Customer Name:		Gallien-Krueger		Current Rev #:		A1		New ECO Rev #:		A2	
Model:		Backline 250, 600, 115 Combo,		Distribute To:				Page:		1 Of: 2	
Assembly Description:		and 210 Combo		Originator:		Enrique Hernandez					
Assembly Numbers:		206-0181-A		Approved by:				Effective Date:		2/15/2005	
Effective				Document Update				Date		Initials	
<input checked="" type="checkbox"/>	All in Process	<input checked="" type="checkbox"/>	Next Buy	<input type="checkbox"/>	Artwork						
<input type="checkbox"/>	All in Service	<input checked="" type="checkbox"/>	Next Production Run	<input type="checkbox"/>	Assembly Dwg.						
<input checked="" type="checkbox"/>	All in Stock	<input type="checkbox"/>		<input type="checkbox"/>	Board Artwork						
Beginning Serial Number:				<input checked="" type="checkbox"/>	BOM						Noli
Reason For Change				<input type="checkbox"/>	Control Form						
Pre-Amp revoiced to sound more like the 400RB-IV.				<input checked="" type="checkbox"/>	Costing						TC

TITLE: BACKLINE 115 PREAMP  
DRAWING NO: 406-0181-A  
REV: A2

Customer Name:		Gallien-Krueger		Current Rev #:	A2	New ECO Rev #:	A3		
Model:		Backline 250, 600, 115 Combo, and 210 Combo		Distribute To:		Page:	1	O

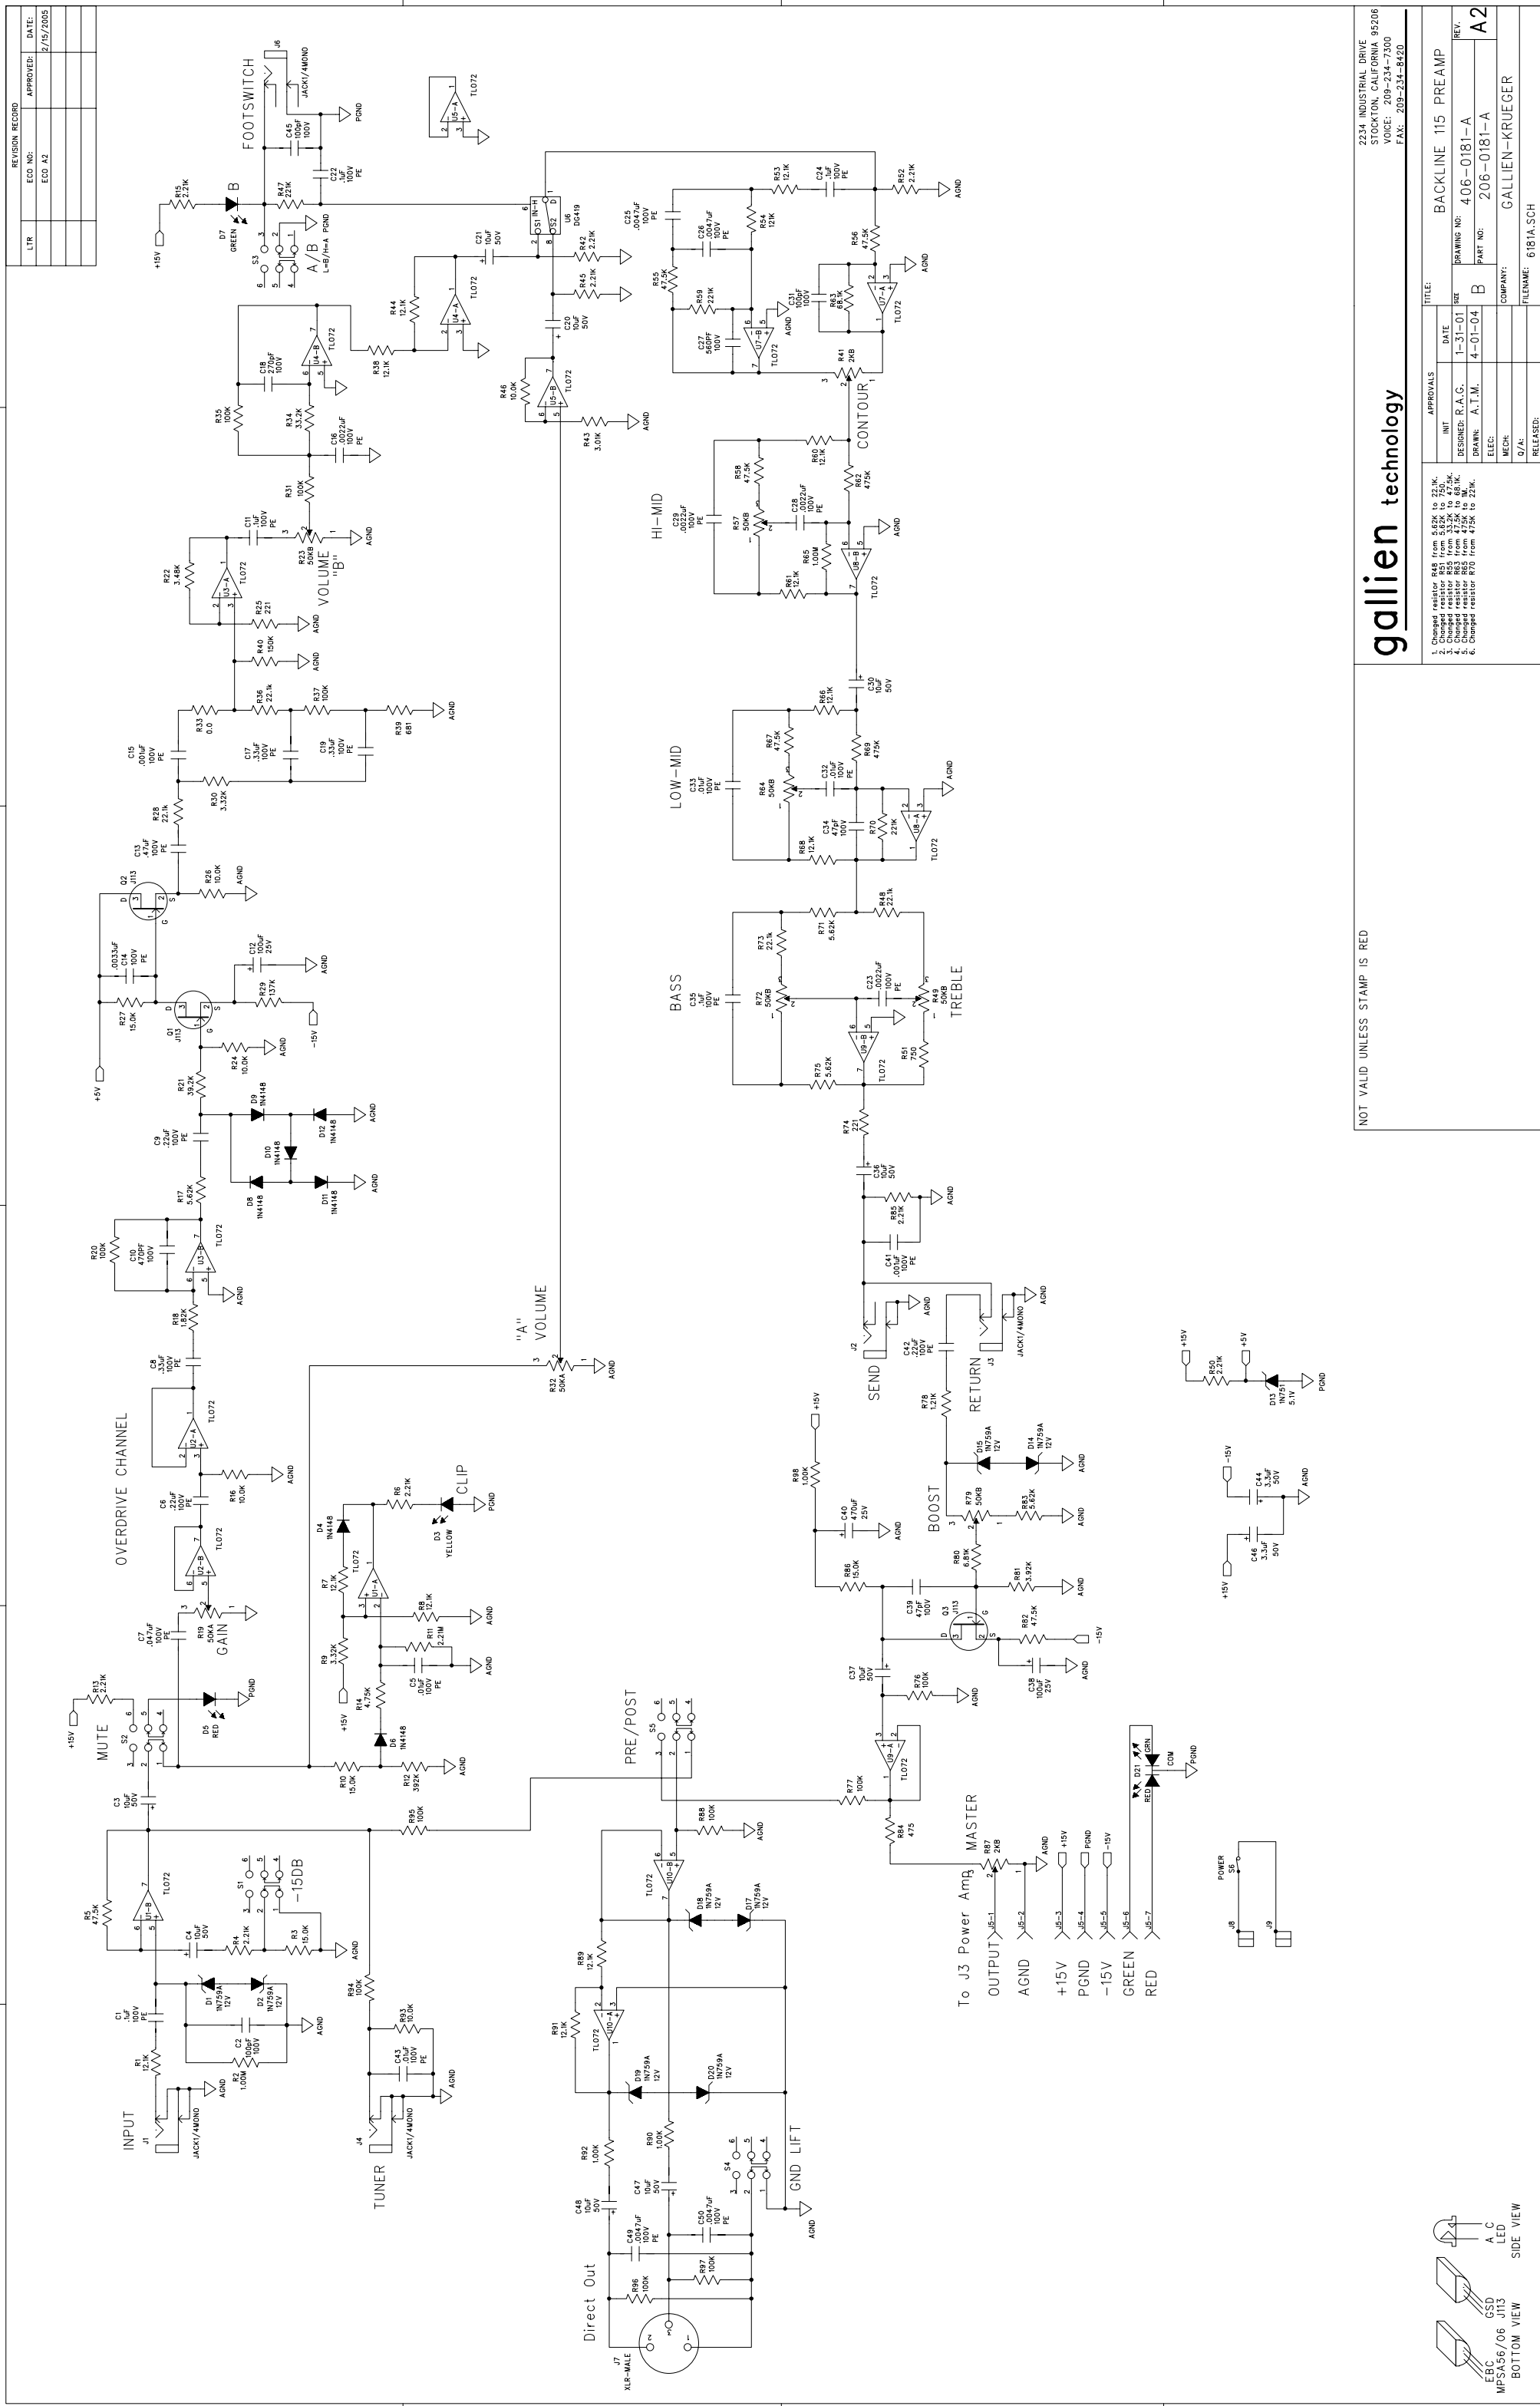
1. Changed resistor R48 from 5.62K to 22K.  
2. Changed resistor R51 from 5.62K to 20K.  
3. Changed resistor R52 from 47.5K to 86K.  
4. Changed resistor R53 from 47.5K to 86K.  
5. Changed resistor R54 from 47.5K to 22K.  
6. Changed resistor R55 from 47.5K to 22K.

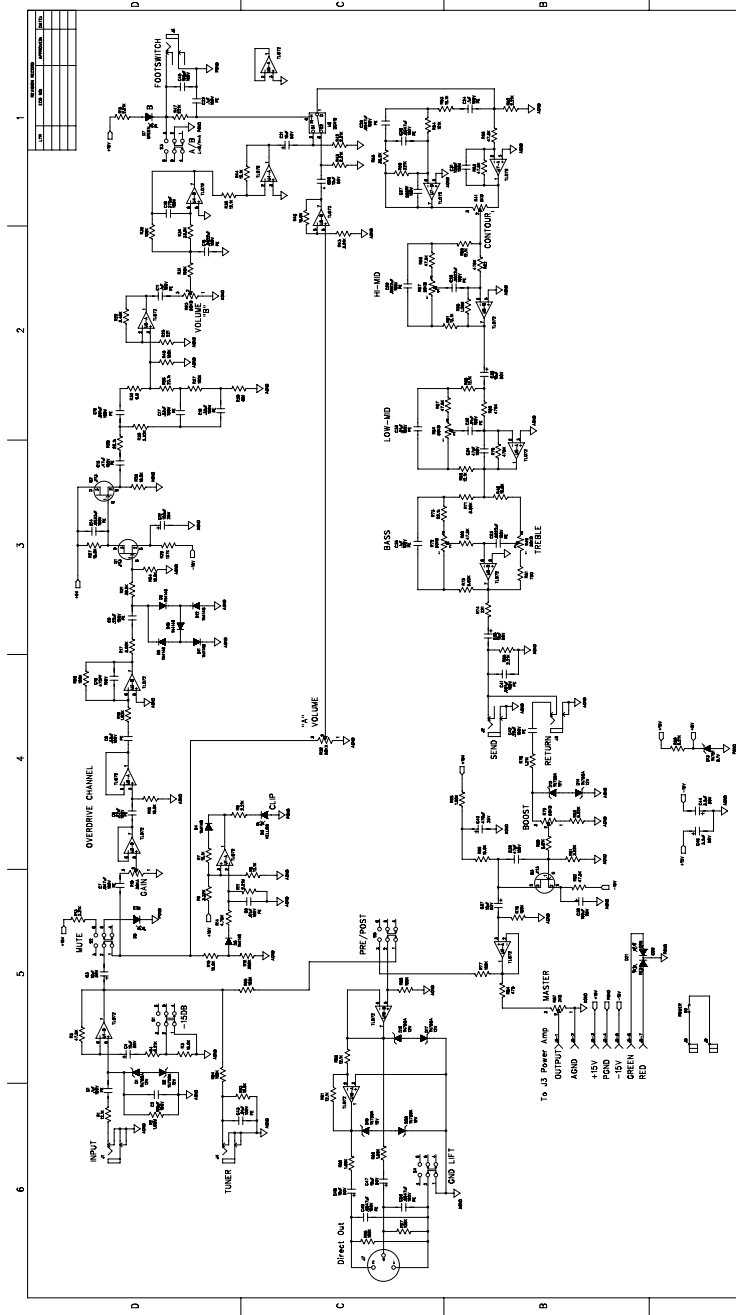
<input checked="" type="checkbox"/>	Incoming Q.C.				
Add a 47.5K resistor as well to bass and treble circuit that is missing, and should be there, it is designated R99 on the schematic 206-0181-A3.				<input type="checkbox"/>	Planning				
				<input checked="" type="checkbox"/>	Production Eng.				
				<input checked="" type="checkbox"/>	Purchasing				
				<input type="checkbox"/>	Q.A.				
				<input type="checkbox"/>	Receiving				
				<input type="checkbox"/>	Service				
				<input type="checkbox"/>	Test				
				<input type="checkbox"/>	Vendor				
				<input type="checkbox"/>					
				<input type="checkbox"/>					
<input type="checkbox"/>	Continued on ECO Supplement Page			<input checked="" type="checkbox"/>	Drawing(s) attached				
Part Number	Description	Parts Added		Parts Deleted					
		Qty	Ref. Designator	Qty	Ref. Designator				
060-2213-0	1/8W, 22.1K			1	R48				
060-1752-0	1/8W, 47.5K			1	R55

APPROVALS		TITLE	
DESIGNED: P.A.G.	DATE: 1-31-01	BACKLINE 115	PREAMP
DRAWN: R.A.C.	DATE: 7/7/08	DRAWING NO:	406-0181-A6
CHECKED:		PART NO:	A6
DATE:		COMPANY:	GALLIEN-KRUEGER
BY:		REVISION:	
DATE:		RELEASED:	
BY:		PREPARED:	6181A6.SCH

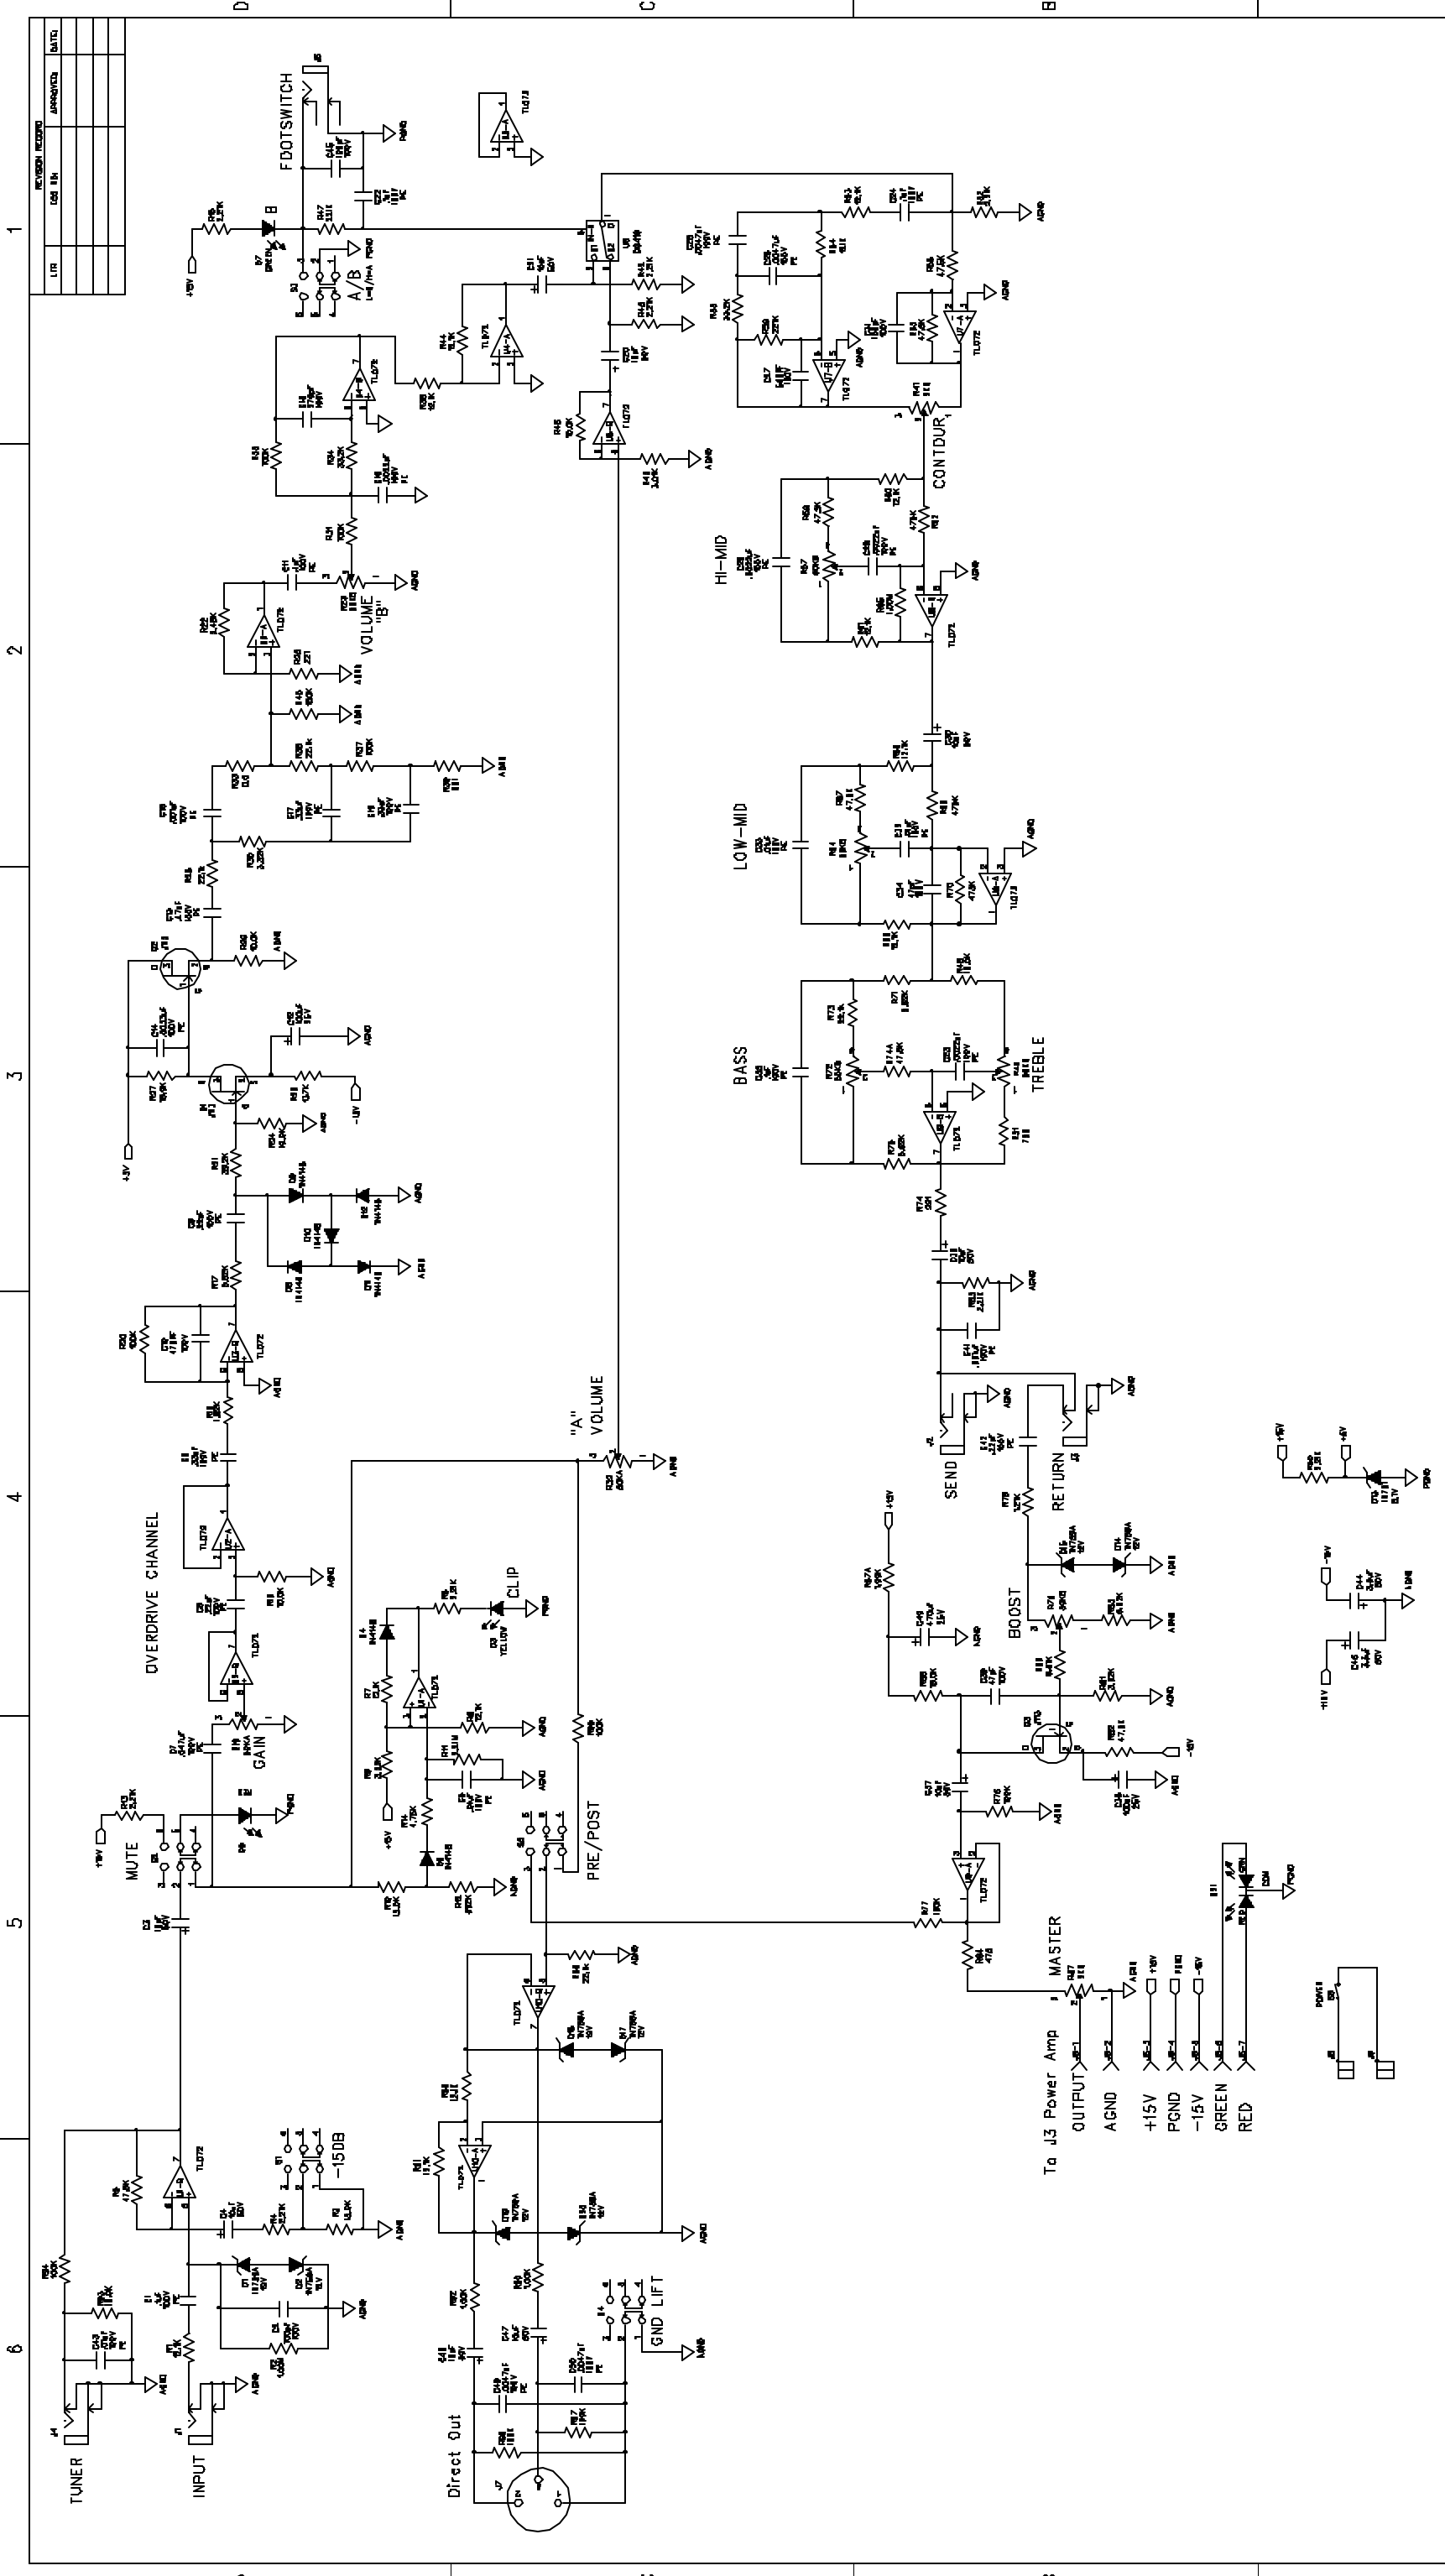
NOTES A6:  
1. MOVE R80 TO TOP OF R32.
